TSIB 26-05 Rev A		June 11, 2026
TO:	All Operators	
TITLE:	New Dampened Crankshaft Pulley Availability	
APPLICABILITY:	This Product Improvement is only applicable to J4500 coaches built prior to Q2-2026, that were equipped with a shock-spring loaded-belt tensioner

Figure 1: Dampened crankshaft pulley

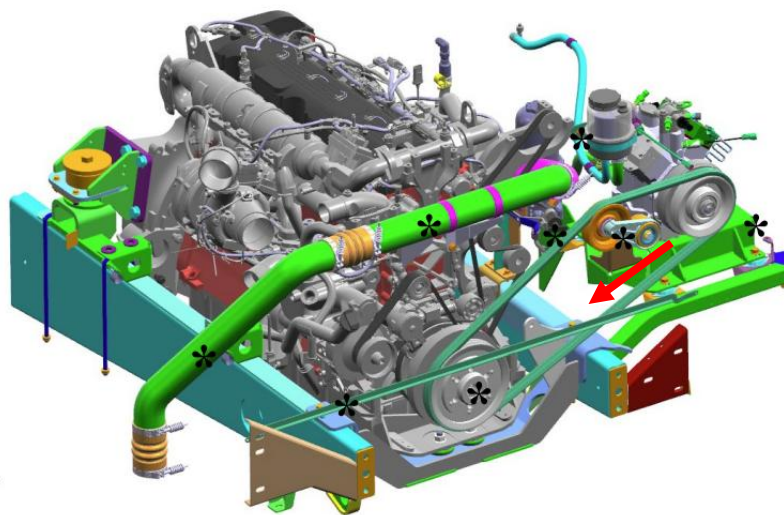
This bulletin introduces an optional product improvement to the A/C compressor drive system. This is not a retrofit or mandatory campaign. The improved pulley system is available for customers who wish to reduce noise and vibration characteristics and may be installed at the customer’s discretion.

Field evaluations have shown that the updated pulley system reduces noise and vibration transmitted from the refrigerant compressor through to the coach frame on vehicles in service. This improvement may enhance passenger comfort and overall NVH performance, particularly in rear seating areas.

If you believe you may be interested in this improvement for your coaches please contact your local MCI parts representative to acquire pricing. Please reference PN 6507829 - Kit - Belt Drive, A/C Compressor (Product Improvement).
